Planning Sub Committee - Wednesday, 17th July, 2024

ADDENDUM REPORT FOR ITEMS

UPDATE FOR CONSIDERATION AT PLANNING SUB-COMMITTEE Item No. 8

London Borough of Haringey Quality Review Panel**Report of Formal Review Meeting: 25-27 Clarendon Road**

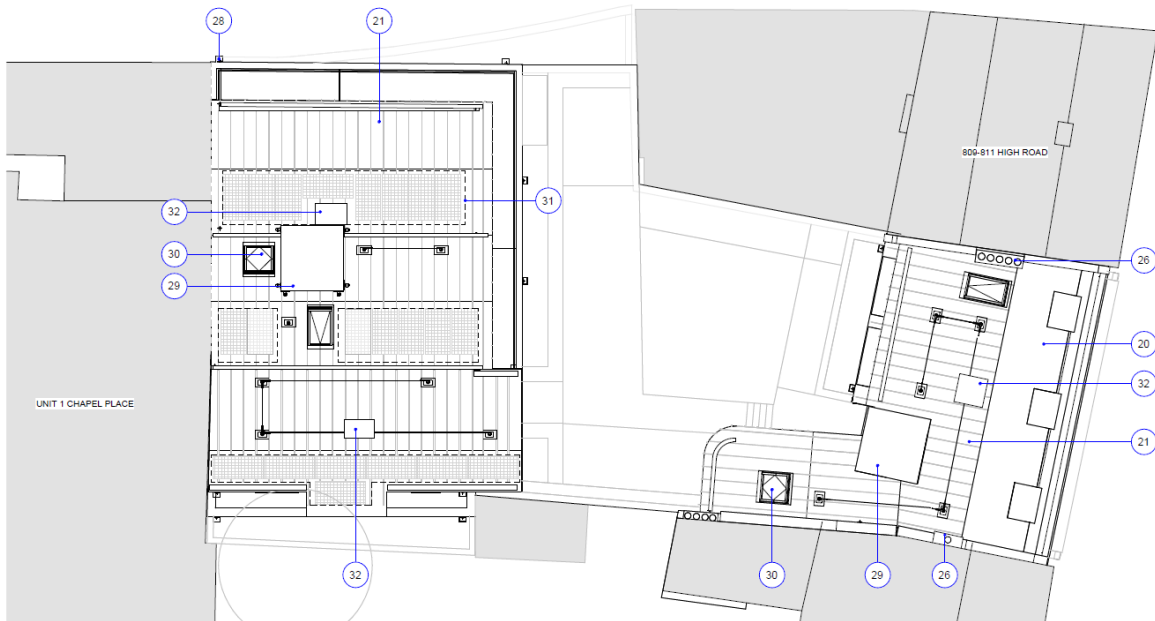
- The Energy use intensity is double in the case of ASHP scenario and four time higher than the GLA benchmark. It is recommended to explore measures to reduce this and aim for the GLA benchmark.
- Please provide proper justification on why the proposed building fabric and heating system results into different EUI and SHD for two different scenarios, which is very high than the GLA benchmark.
